SUBJECT: Forwards rev 18 to emergency plan, description of changes & safety evaluations & supporting documents for rev.

Docket 50-305
Operating License DPR-43
Kewaunee Nuclear Power Plant
Emergency Plan Revision 18

EMERGENCY PLAN REVISION 18

FIGURE 5-1.2

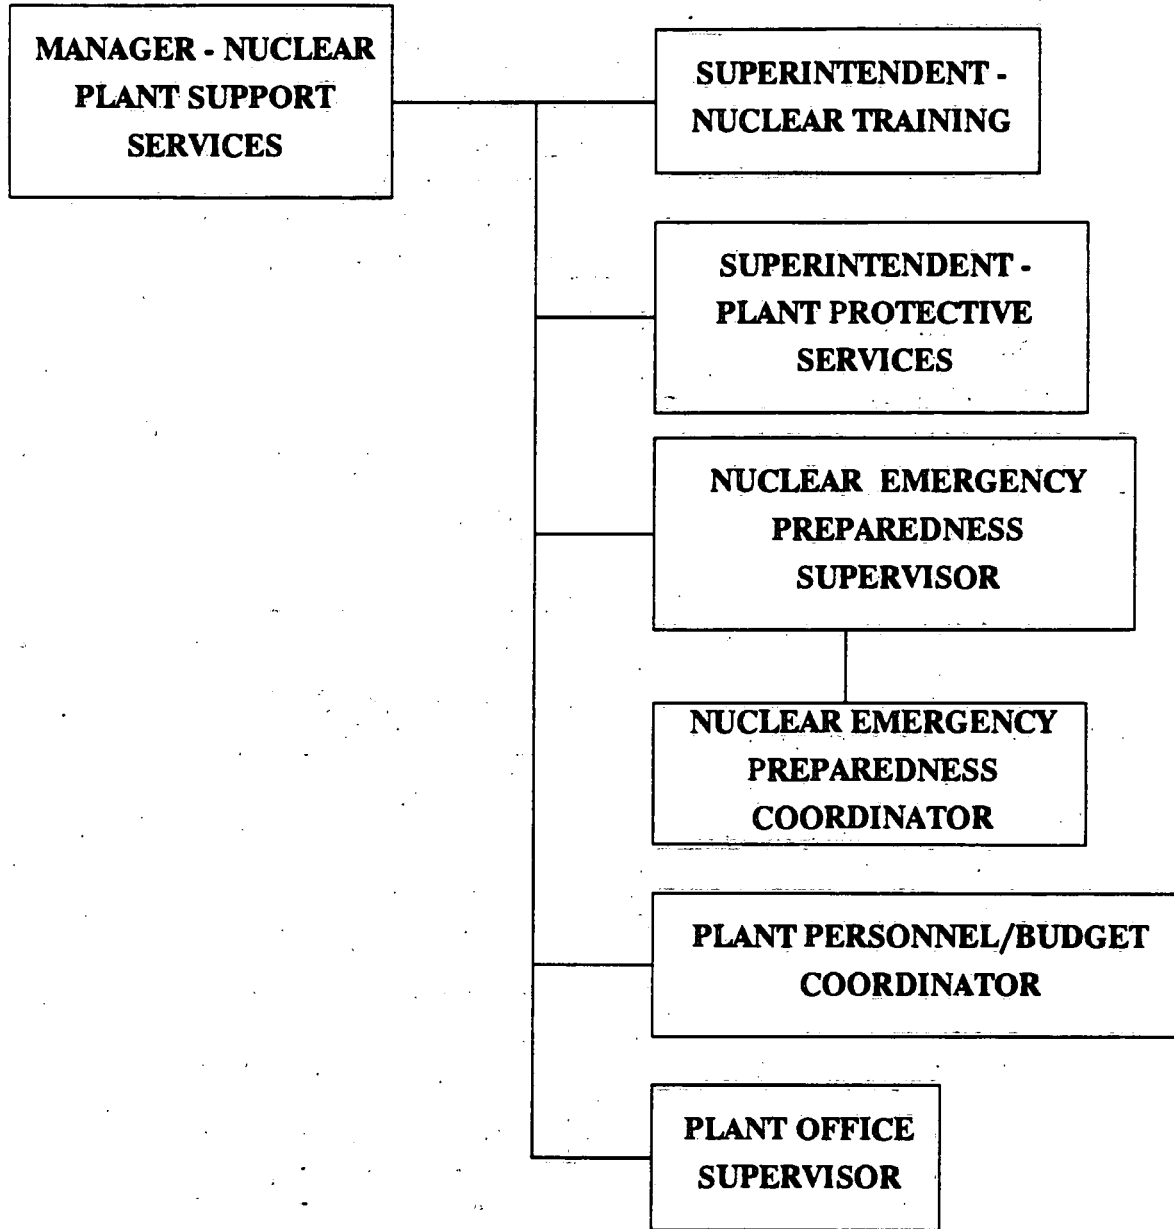
Fig. 5-1.2 **Description of Change**

- a. The Nuclear Emergency Preparedness Coordinator was modified to show one coordinator position.
- b. The Nuclear Personnel Supervisor title was changed to Plant Personnel/Budget Coordinator.
- c. The Plant Office Supervisor position was added.

- a. A company wide personnel reduction policy was imposed when the one of the two coordinator positions was vacated do to a job transfer. The second position was eliminated. Added support was provided from the plant training group and the plant administrative group. This change does not decrease the effectiveness of the plan.
- b. Due to a consolidation of positions the responsibilities of personnel and budgeting was also consolidated under one person. This change does not decrease the effectiveness of the plan.
- c. This change does not decrease the effectiveness of the plan.

FIGURE 5-13

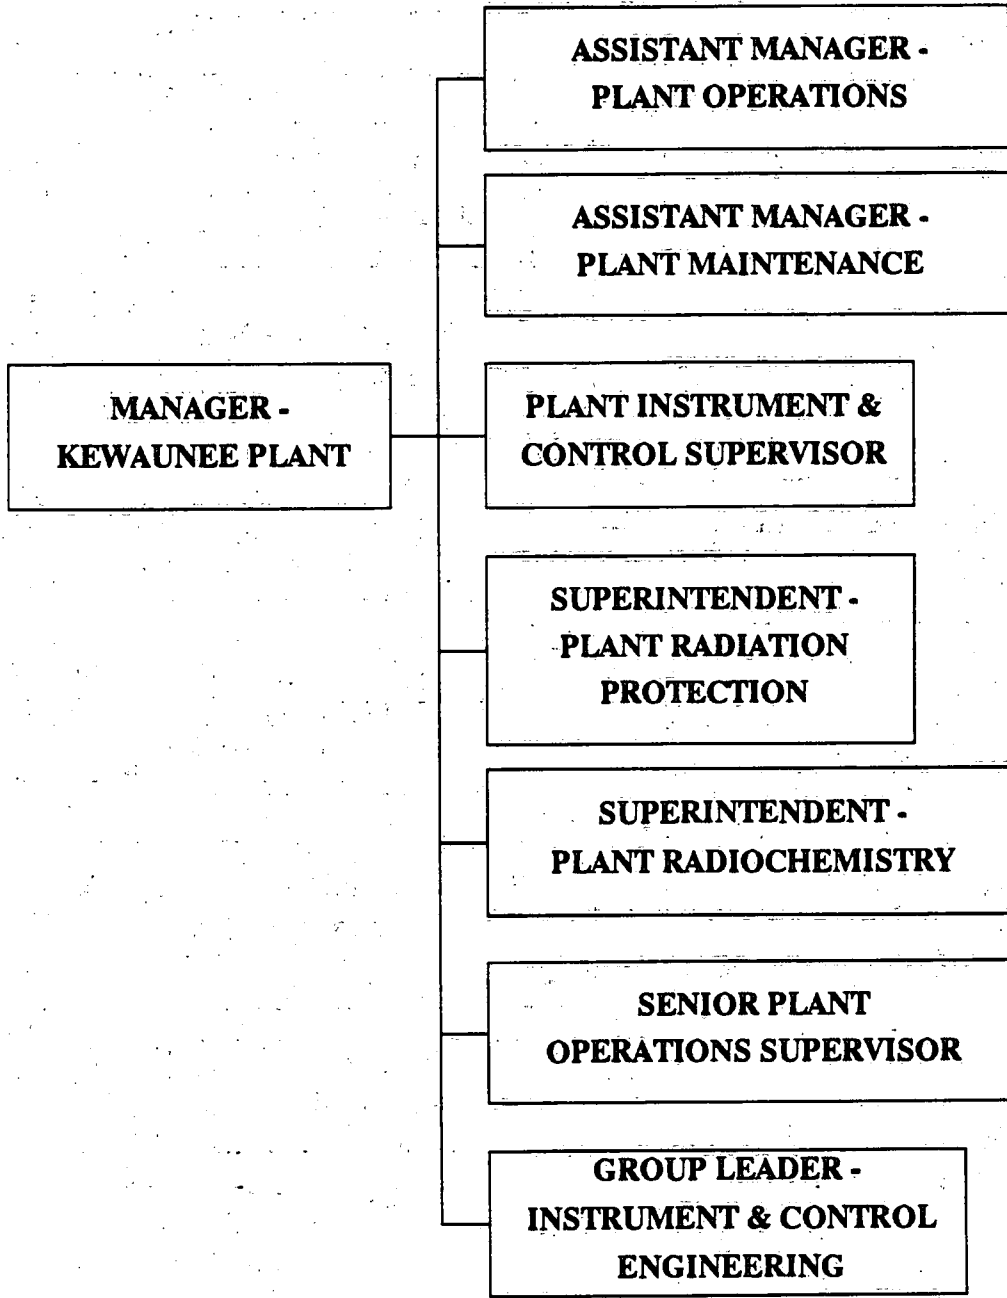
Fig. 5-1.3 **Description of Change**

The title "Superintendent - Plant Instrument and Control" was changed to "Plant Instrument and Control Supervisor." The position "Group Leader - Instrument and Control Engineering" was added to the figure.

This change is administrative in nature that does not affect the availability of instrument and control support. this change does not decrease the effectiveness of the plan.

FIGURE 5-1.5

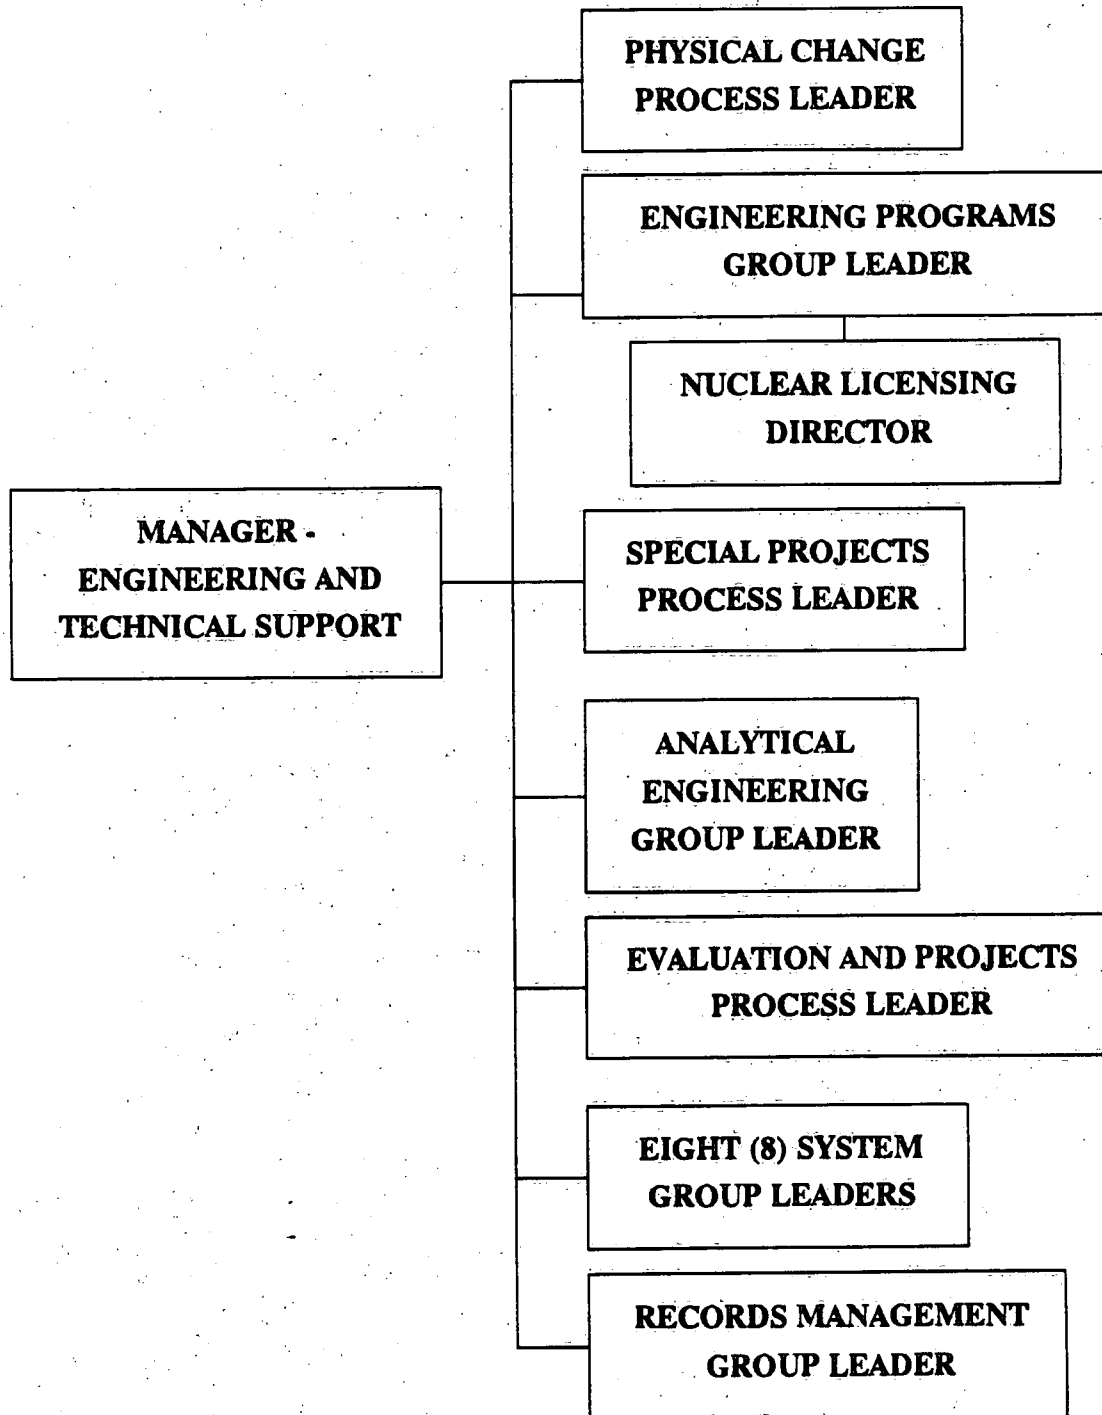
Fig. 5-1.5 Description of Change

- a. The positions "Special Projects Process Leader" and "Records Management Group Leader" were added to the figure.
- b. The title "Projects Evaluation Process Leader" was changed to "Evaluation and Projects Process Leader."

a&b. These changes are administrative in nature and do not decrease the availability of plant support. This change does not decrease the effectiveness of the plan.

**FIGURE 6-2
INITIAL OFF-SITE NOTIFICATION**

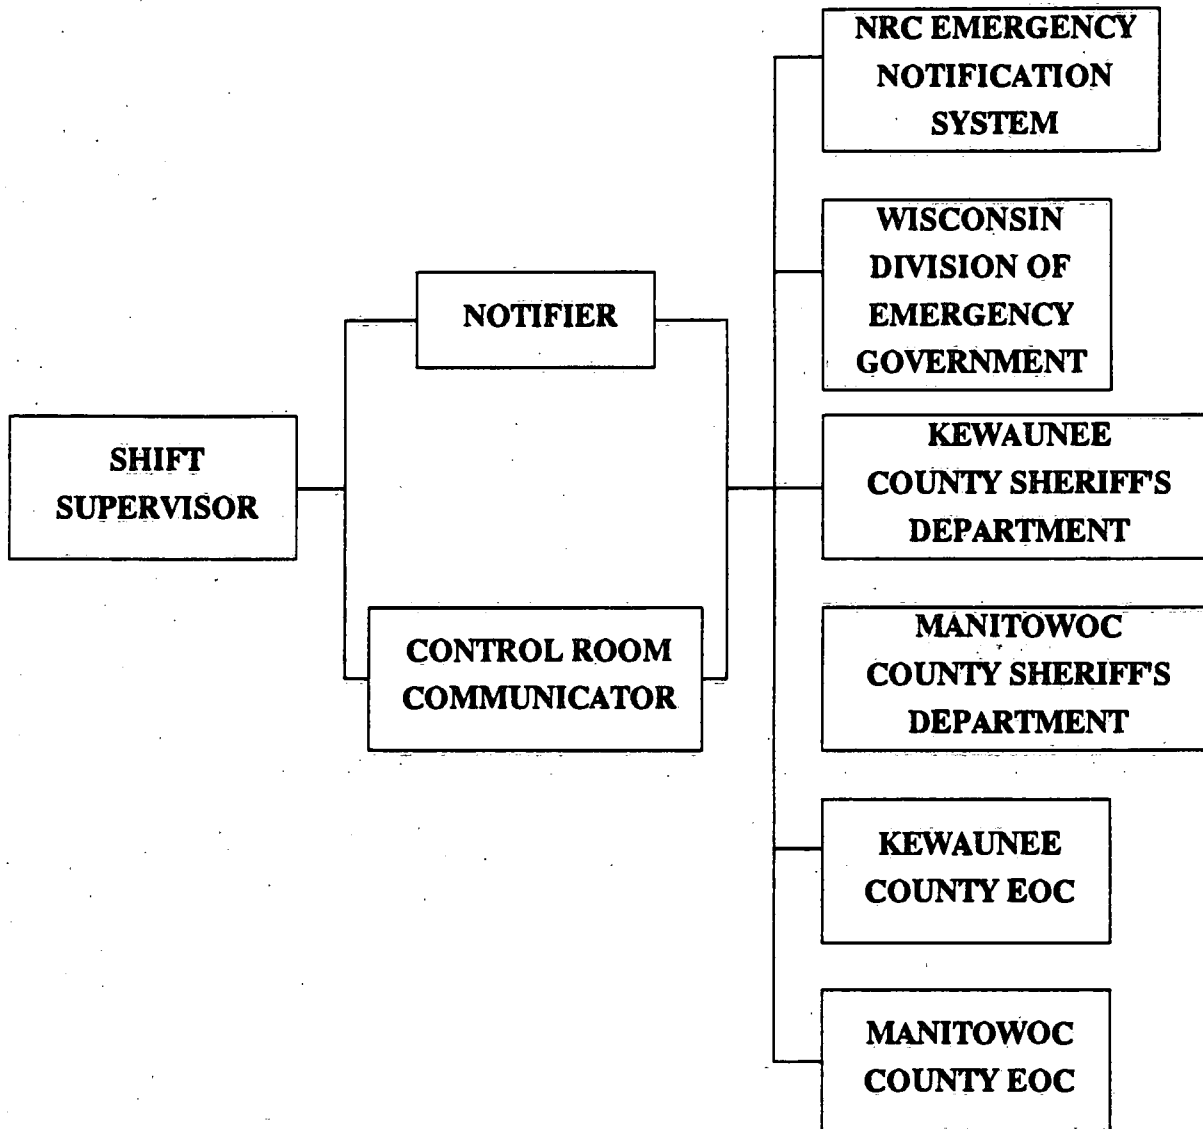
Fig. 6-2 Description of Change

These are no longer notified directly by the utility and provide no direct or immediate support during the early stages of a declared emergency. They are, however, contacted for support as needed by the State of Wisconsin, Division of Emergency Government. This change does not decrease the effectiveness of the plan.

**FIGURE 7-2
OFF-SITE COMMUNICATIONS NETWORK**

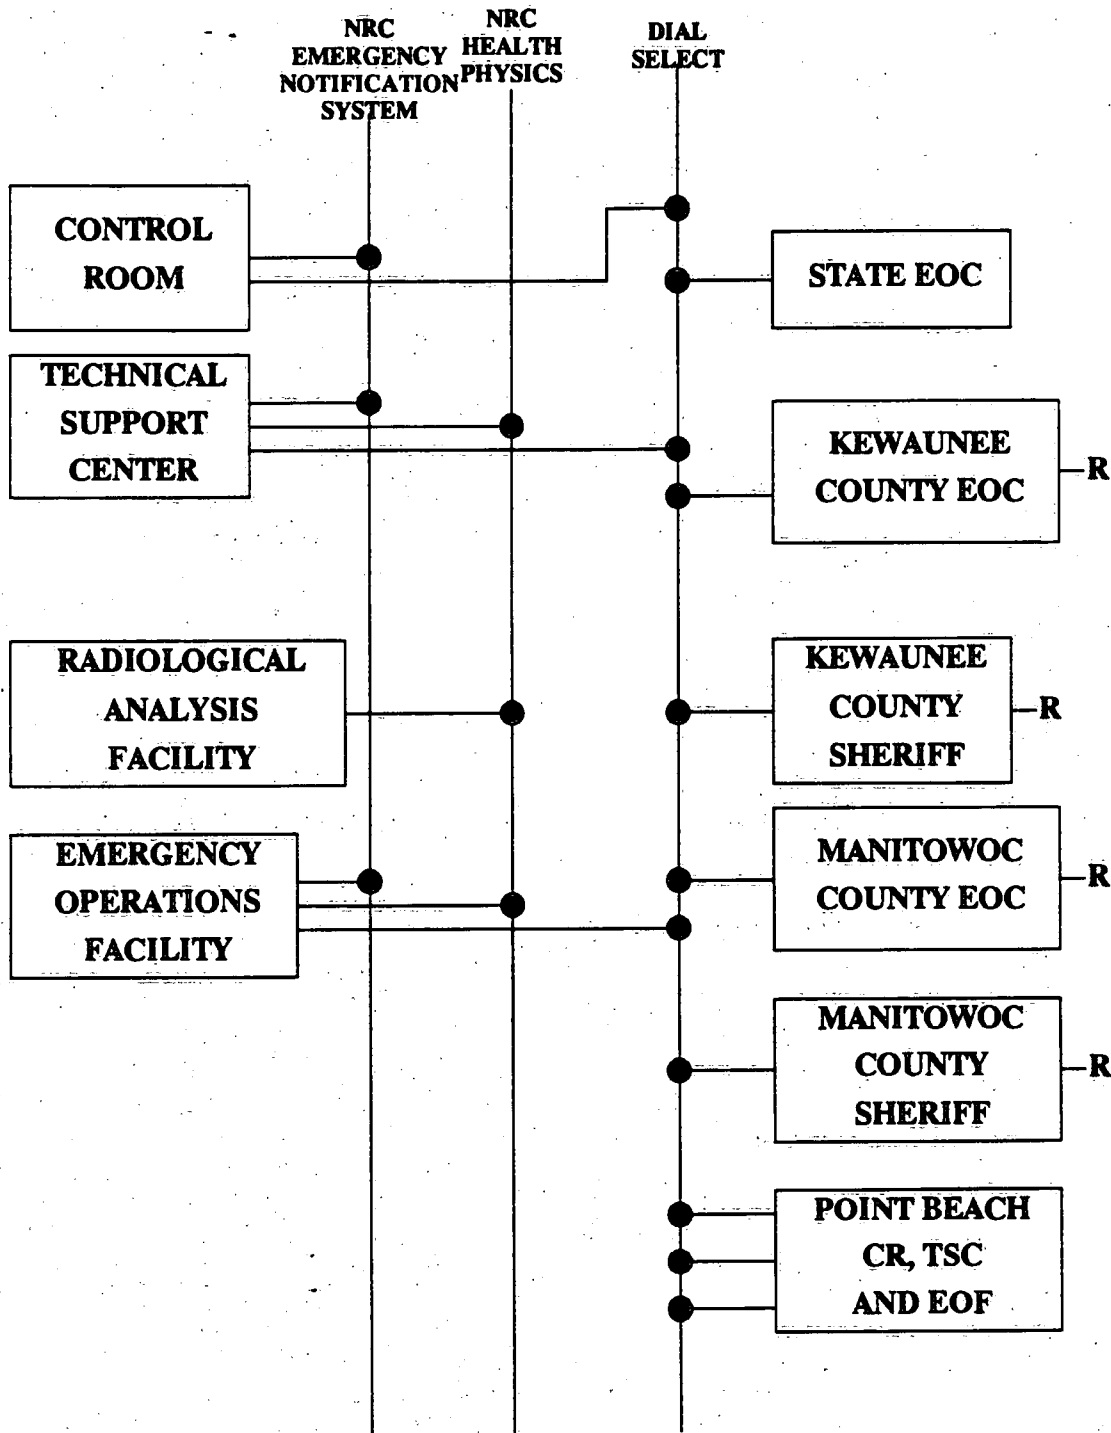
Fig. 7-2 Description of Change

The NAWAS was removed in total from all utility emergency response facilities in August of 1995. The NAWAS has been for several years a back up to a shared primary notification system call Dial-Select, a dedicated open circuit system. When the Federal Government announced that Federal funding for the system was being eliminated the State and County emergency governments started discussions to eliminate the use of this system also. Since all parties were confident with the operation of the Dial-Select system, the State and Counties were supportive of elimination of the NAWAS at the utilities. This change does not decrease the effectiveness of the plan.

FIGURE C-4
POPULATION DISTRIBUTION
BY EVACUATION AREAS
KEWAUNEE NUCLEAR POWER PLANT
KEWAUNEE AND MANITOWOC COUNTIES

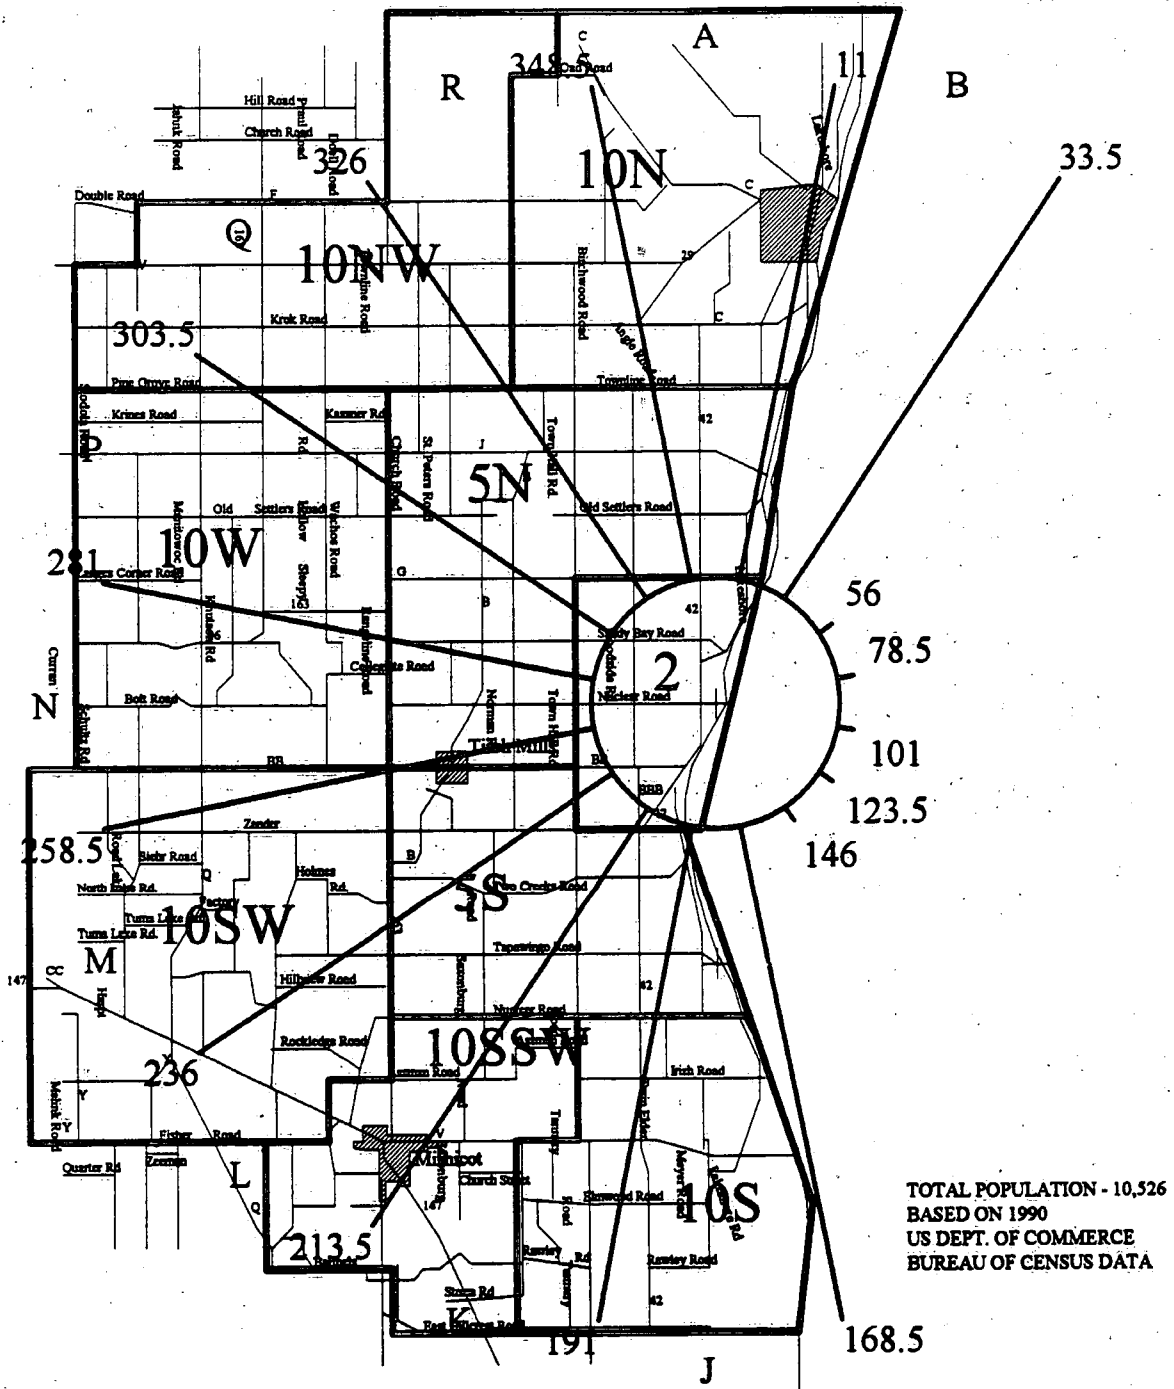
The population distribution by evacuation area map was replaced with only minor format changes and no change to content.

This change provides a map that is clearer and easier to read. This change does not decrease the effectiveness of the plan.
